RTML layout in SB2009

CFS/Area system Workshop 2, SLAC, August 2-3, 2010

Corrections in CFS drawings (LCWS 09)

RTML in Central Area

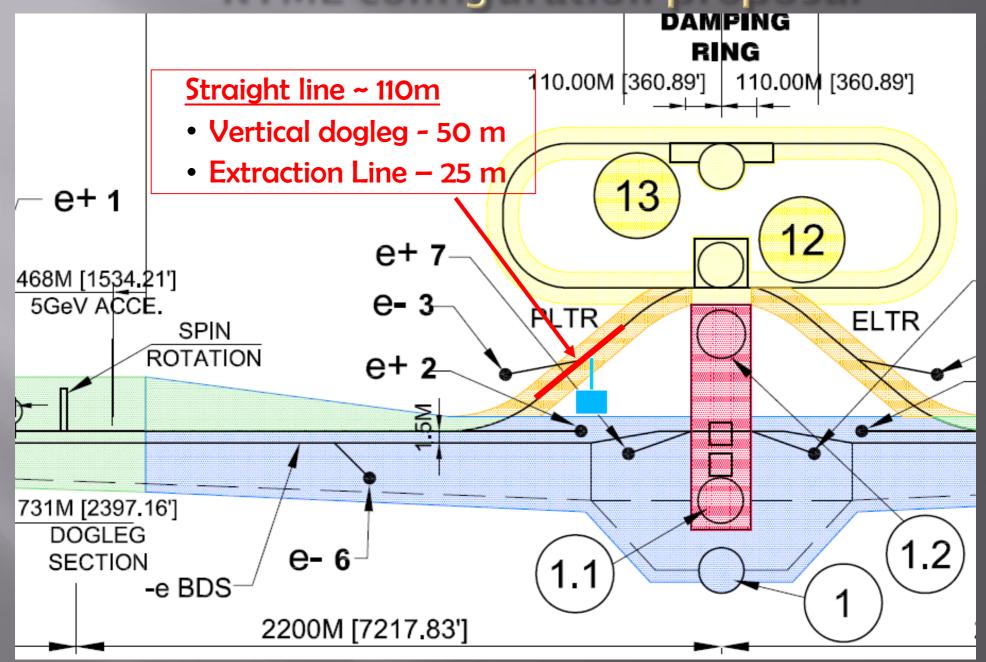
- In SB2009 DR circumference has been scaled down to 3.2 km
- RDR design foresaw an extraction at about 1 km from the central plane (IP location) in the direction of the turnaround, now the DR exit is located at about 100 meters from the central plane → RTML system longer by ~900 m, more RT magnets.
- It requires redesign of the RDR beamlines. Possible simplification of overall layout due to DR in same elevation. Preliminary lattice exist, no matching and optimization done yet.
- Possible risks might arise from the performances of the new system from the point of view of the low emittance transport

ILC - Central Integration SB 2009 Layout

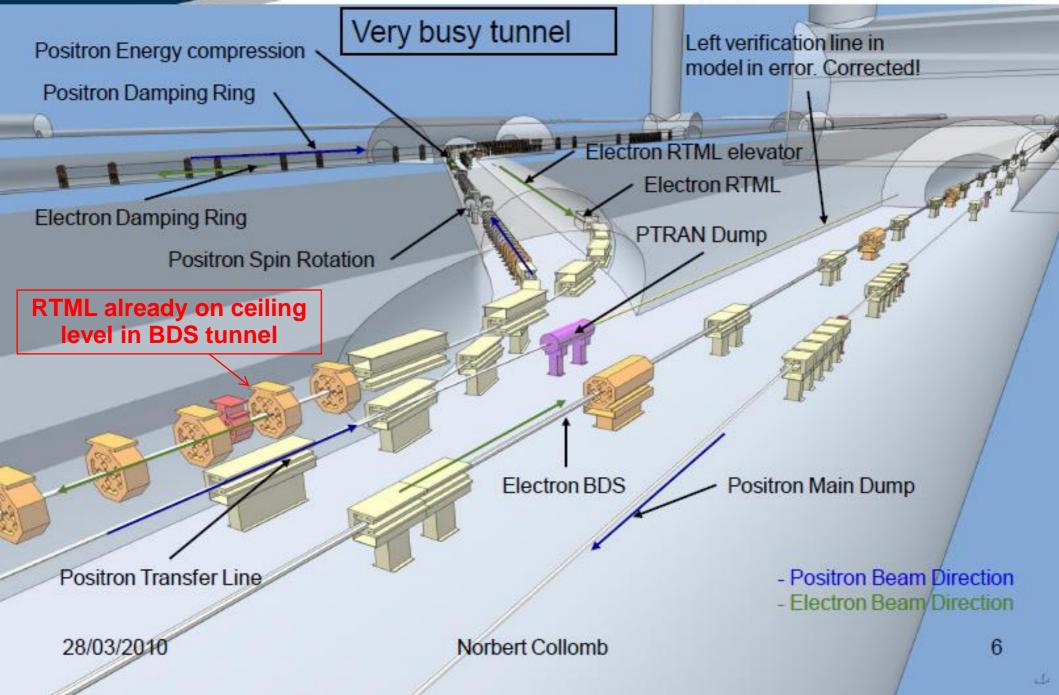
Quite a bit of guess work going on at this moment. There are 9 Beam Dumps in the Transfer Tunnel?

Need more details on RTML beam-line in this Area:

Extraction line and Dump?
